Re: <u>EA1415-001, Prairie Creek Mine All Season Access Road</u> Response to Technical Reports

RESPONSES TO TECHNICAL REPORTS – EA1415-01

Figure 1 Proposed diversion compared to Sundog Creek from headwaters to confluence with Ram River.

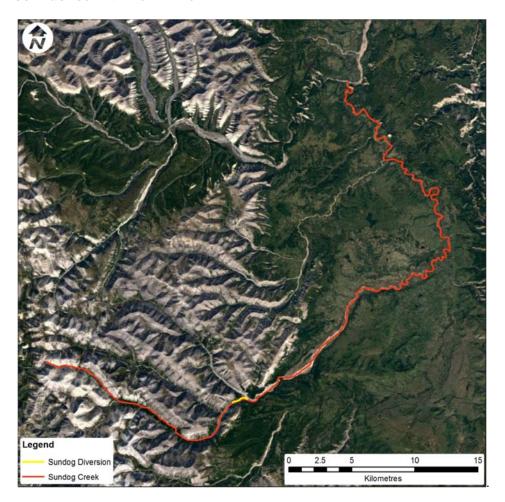
1. Anticipated low abundance of benthic invertebrates within the diversion area – the diversion is within the headwaters of Sundog Creek, the habitat is oligotrophic and substrates are generally cobble and unstable. Portions of the channel in the area of the diversion also naturally dry up in the summer and stay dry throughout the winter. Ice within Nahanni National Park Reserve is often 1m thick, and therefore ice will form well into substrates. Due to the above reasons, habitat for benthic invertebrates is poor and indicates that resident assemblages will be low and commonly in a state of stress and recovery. In our opinion, the colonization of the newly diverted channel (within the active floodplain) will likely occur at a similar rate as the existing channel from the natural seasonal disruptions it often experiences. Downstream of the diversion, gradients decrease and the stream is flanked by forests. We would anticipate that the downstream areas of Sundog support much higher relative benthic invertebrate densities¹;

- The small relative area the diversion represents a very small portion of Sundog Creek (see Figure 1), therefore the contribution of benthic invertebrates from this section of Sundog Creek is likely a small fraction of drift insects available to downstream fish; and
- 3. The low importance of benthic drift to downstream fish populations In Alaskan streams, drifting benthic invertebrates contribute relatively little biomass to the diet of downstream resident fish (12.4%¹). Sundog Creek is likely to have lower productivity in proximity to the realignment because it is nutrient poor. Any shift in benthic invertebrate community is not likely to have a significant influence on the food supply of downstream fish.
